**ADDENDUM NUMBER 1  
BREWSTER STREET DRAINAGE OUTFALL**

BID PROPOSAL #23-15  
Bid due Date and Time: March 23, 2015 at 2 pm

Issued: 3-17-15

This Addendum forms part of the original document marked: **Brewster Street Drainage Outfall, Bid Proposal #23-15.**

REVISED DMH4 AND WQU-B PIPING  
 NEW DMH4A AND CB3 PLAN

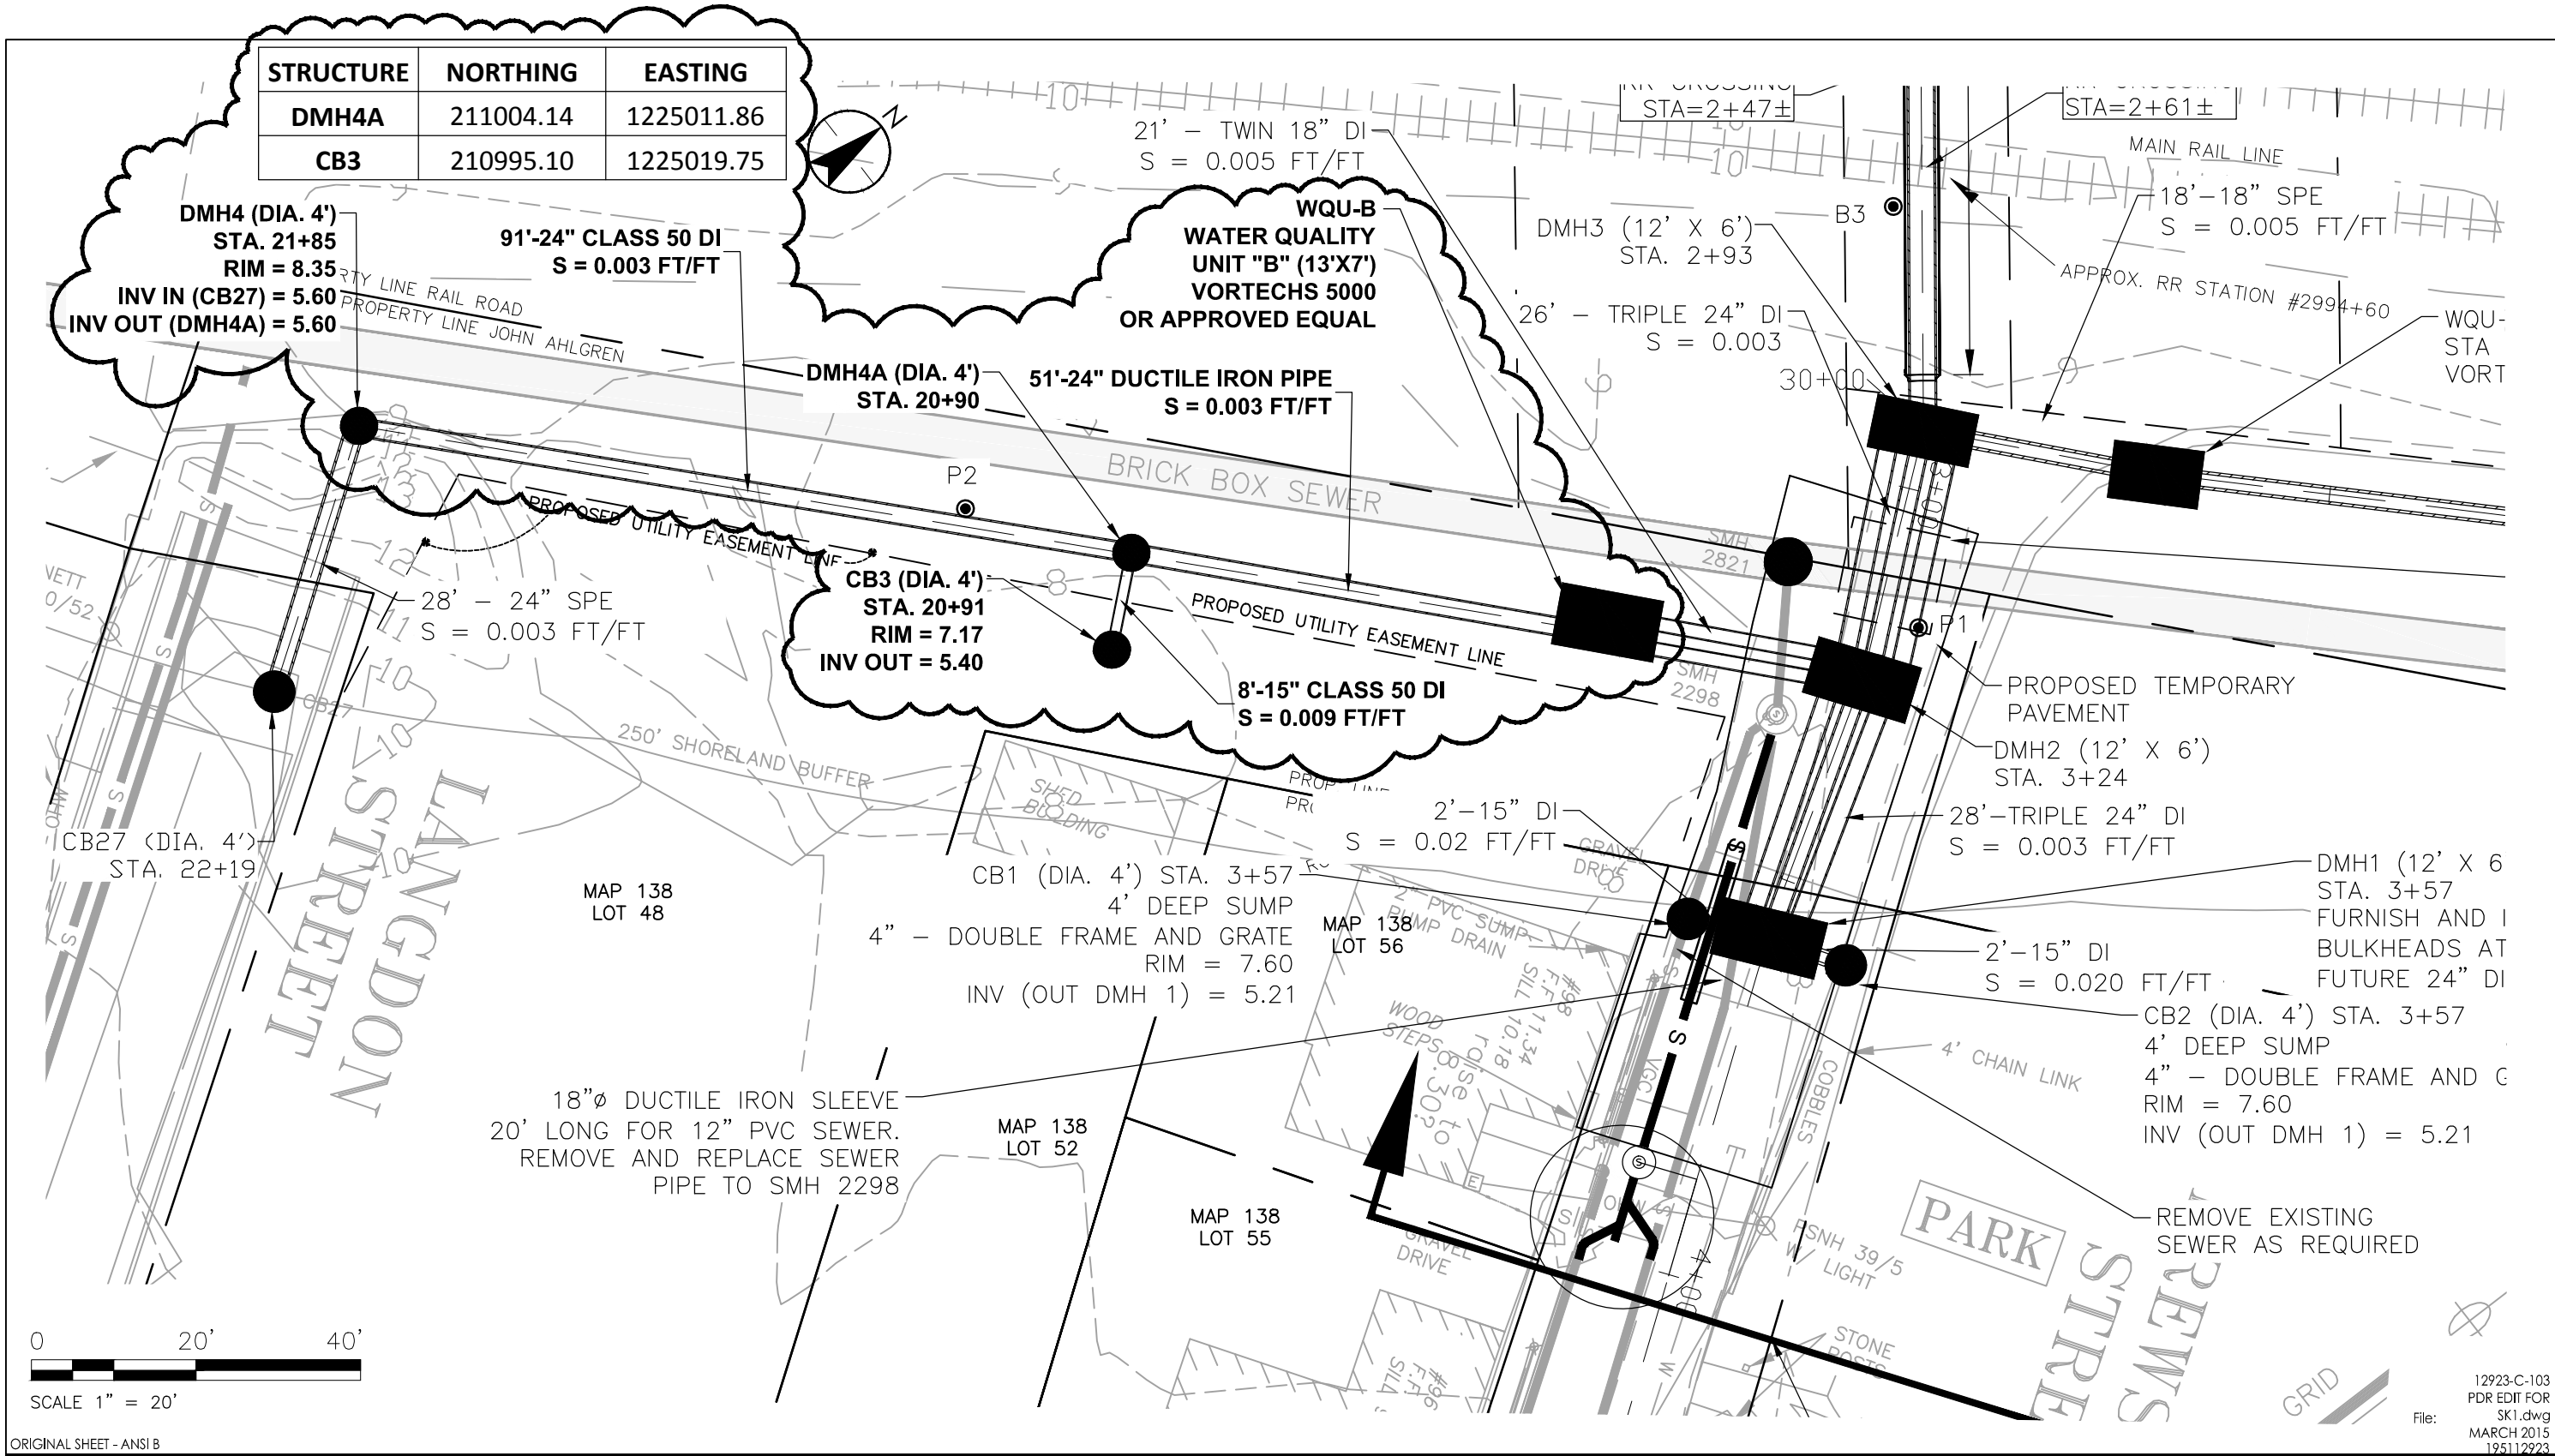
2. Plan Sheet C-101 – Modify and/or change this plan sheet in accordance with changes shown on attached SK-1 – REVISED DMH4 AND WQU-B PIPING NEW DMH4A AND CB3 PLAN.
3. Plan Sheet P-101 – Modify and/or change this plan sheet in accordance with changes shown on attached SK-1 – REVISED DMH4 AND WQU-B PIPING NEW DMH4A AND CB3 PLAN.
4. Plan Sheet 7 of 9 – Add Name “DET3” to the Title Block.
5. Plan Sheet DET4 – Modify and/or change this plan sheet in accordance with changes shown on attached SK-2 – REVISED WQU-B AND NEW DMH4A DETAILS.

STRUCTURE	NORTHING	EASTING
DMH4A	211004.14	1225011.86
CB3	210995.10	1225019.75
